Model: Kir-C ARDF (DF71)	Date: 25-May-01	No.: MB379001a
--------------------------	-----------------	----------------

MB Correction

Modified Article: Parts Catalog Correction		Prepared by: K. Miura	
From: Technical Services Dept., GTS Division			
Reason for Modification:	<input checked="" type="checkbox"/> Parts catalog correction	<input type="checkbox"/> Vendor change	<input type="checkbox"/> To meet standards ()
	<input type="checkbox"/> To facilitate assembly	<input type="checkbox"/> To improve reliability	
	<input type="checkbox"/> Part standardization	<input type="checkbox"/> Other

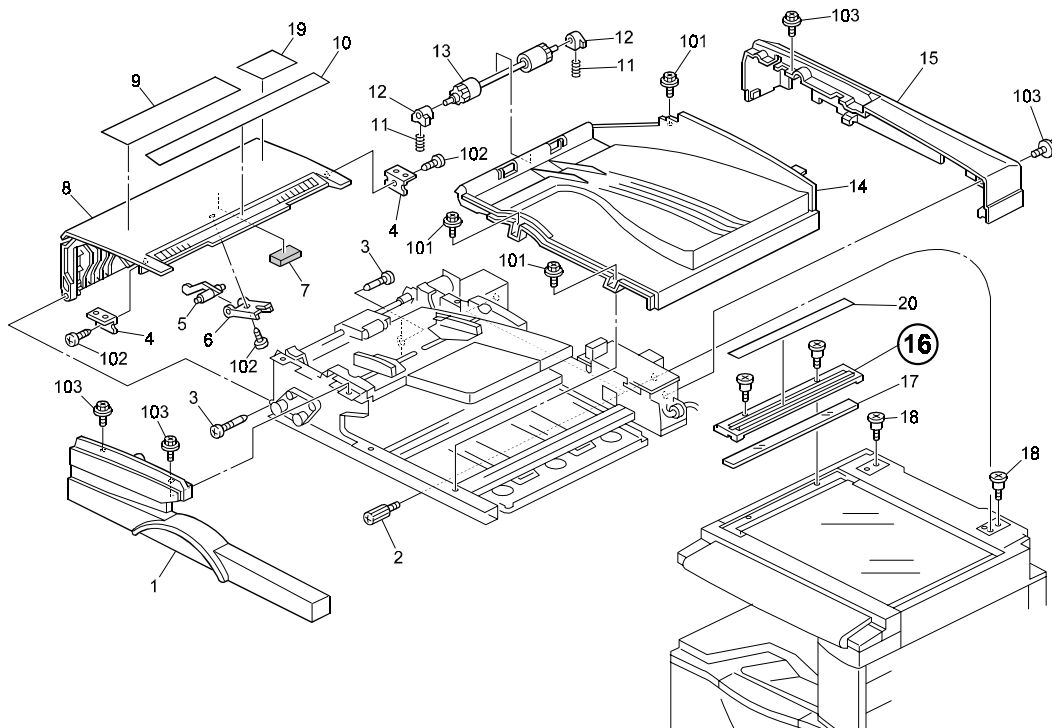
The shape of the Original Scale has been changed to ensure smoother feed of originals.

Old part number	New part number	Description	Q'ty	Int	Page	Index	Note
B3867101	B3867102	Original Scale	1	O/O	3	16

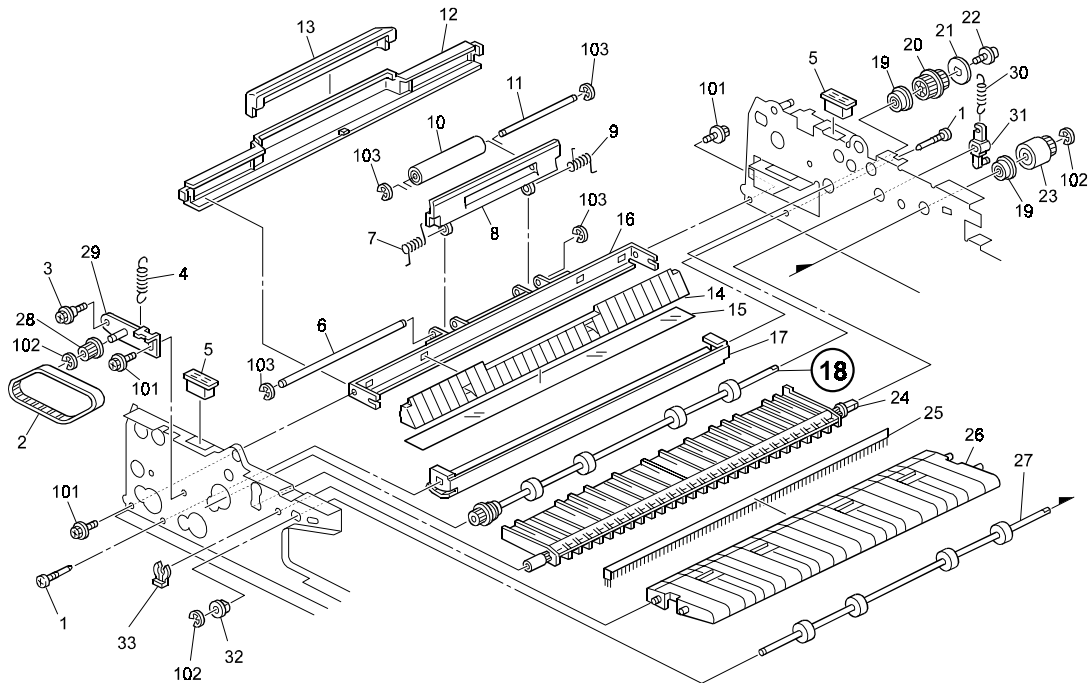
To minimize vibration of originals during paper feed, the following has been changed:

Old part number	New part number	Description	Q'ty	Int	Page	Index	Note
A8593130	B3863130	Exit Roller - Drive	1	O/O	9	18

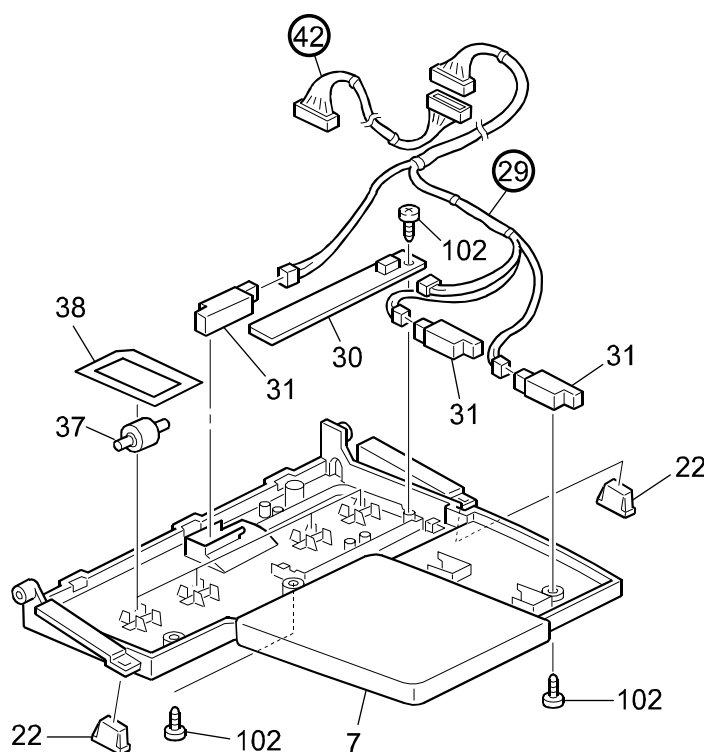
The following have been changed in accordance with parts used on the Model-UC for EMI Standards certification.

Old part number	New part number	Description	Q'ty	Int	Page	Index	Note
A8595702	B4895715	Harness - Original Tray	1	X/X	5	29	
	B4895713	Relay harness	1	X/X	5	42

Note: When installing the new Original Tray Harness (B4895715), it is also necessary to install the Relay Harness (B4895713) at the same time. The interchangeability as a set for these parts is O/O.

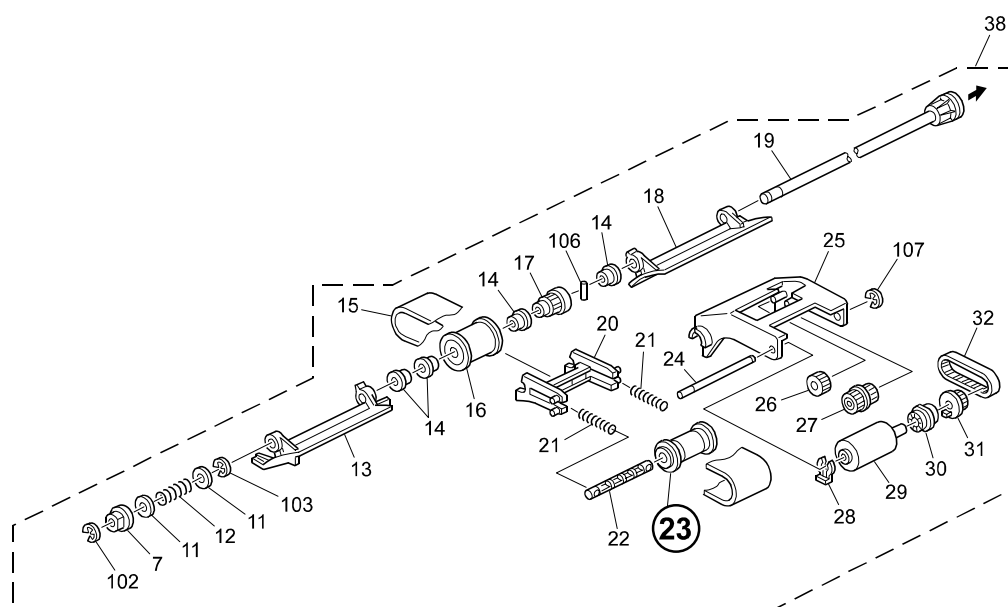
The following has been changed due to parts standardization with other models.

Old part number	New part number	Description	Q'ty	Int	Page	Index	Note
A8592113		Drive Roller - Paper Feed Belt	1		7	23	
	B3872113	Roller - Paper Feed Belt	1	O/O	7	23

<Page 3>

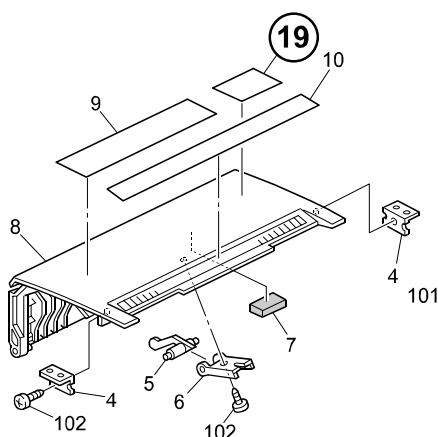
Explanations in four display languages have been added to the following decal.

Old part number	New part number	Description	Q'ty	Int	Page	Index	Note
B3796063	G5646077	Exposure Glass Decal	1	X/O	3 17	19 3

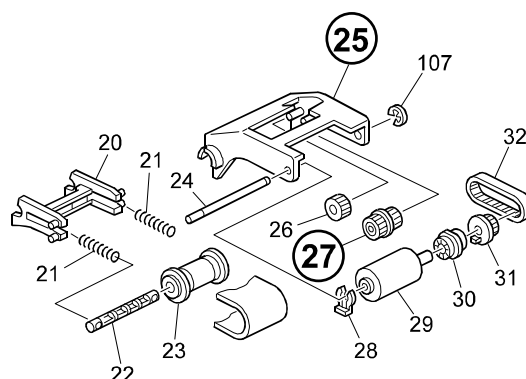
The following have been changed to further ensure that the shaft of the Pickup Holder for the Pulley is not damaged.

Old part number	New part number	Description	Q'ty	Int	Page	Index	Note
A8592151	G4123821	Holder - Pick Up	1	X/X	7	25	
A8592168	G4123831	Pulley - 22Z	1	X/X	7	27

Note: These parts must be replaced together as a set.

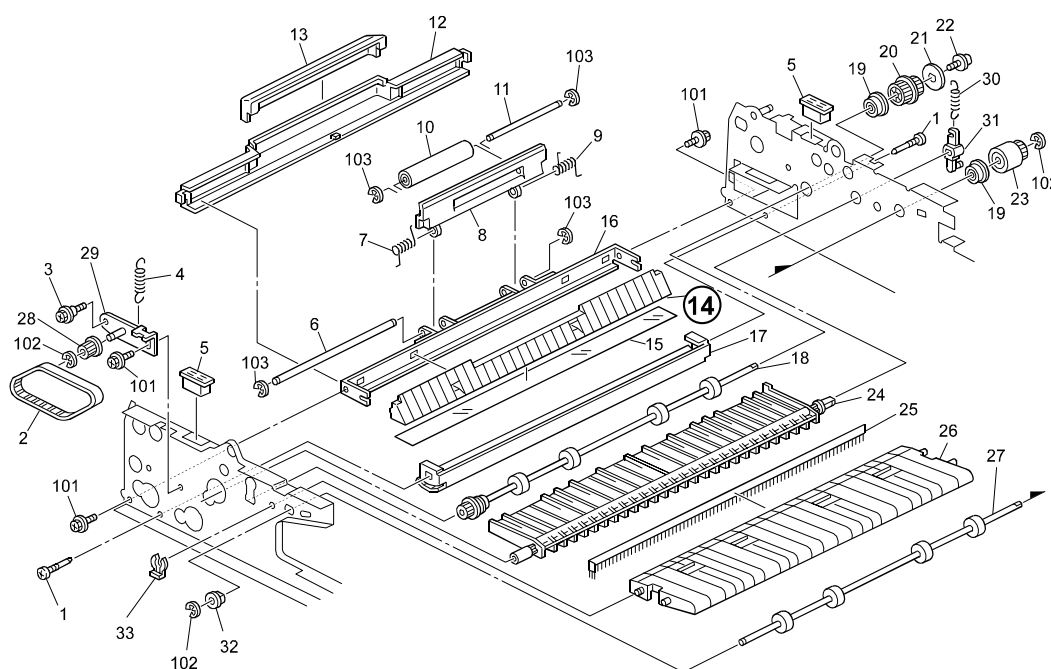
To ensure the junctions of the Lower Left Guide stay properly in position when the ADF is installed, the guide has been changed.

Old part number	New part number	Description	Q'ty	Int	Page	Index	Note
A8591721	A8591723	Left Lower Guide	1	X/O	9	14
